HOPE CREEK GENERATING STATION
EVENT CLASSIFICATION GUIDE TECHNICAL BASIS
April 19, 2002

CHANGE PAGES FOR
REVISION #17

**HOPE CREEK ECG TECHNICAL BASIS
 TABLE OF CONTENTS/SIGNATURE PAGE**

REVISION SUMMARY

SYSTEM ACTUATION FLOW CHART

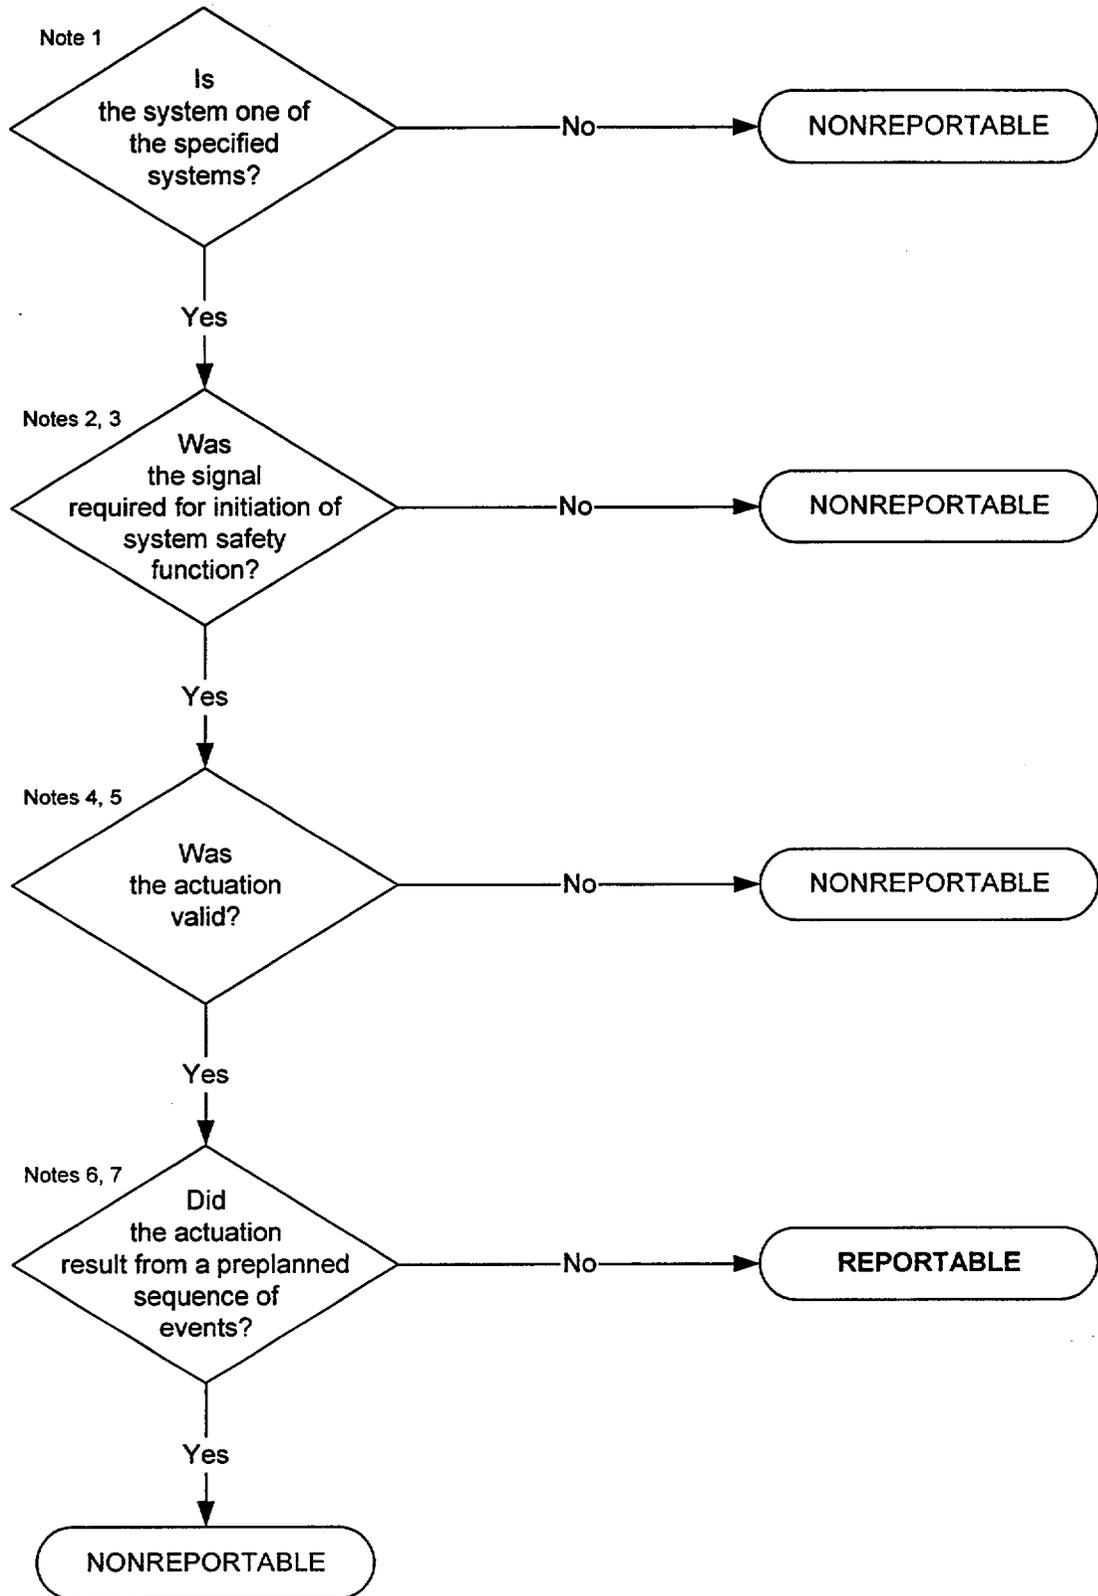
- 11.3.3 Technical Basis - added statement that an actuation cannot be considered invalid if it results from an actual system parameter reaching its set point.

5. Invalid actuations are by definition those that do not meet the criteria for being valid. Invalid actuations can include instrument drift, spurious signals, human error, jarring a cabinet, an error in the use of jumpers or lifted leads, an error in the actuation of switches or controls, equipment failure, or radio frequency interference. Invalid actuations do not include actuations from the sensor by measurement of an actual physical system parameter that was at its setpoint.
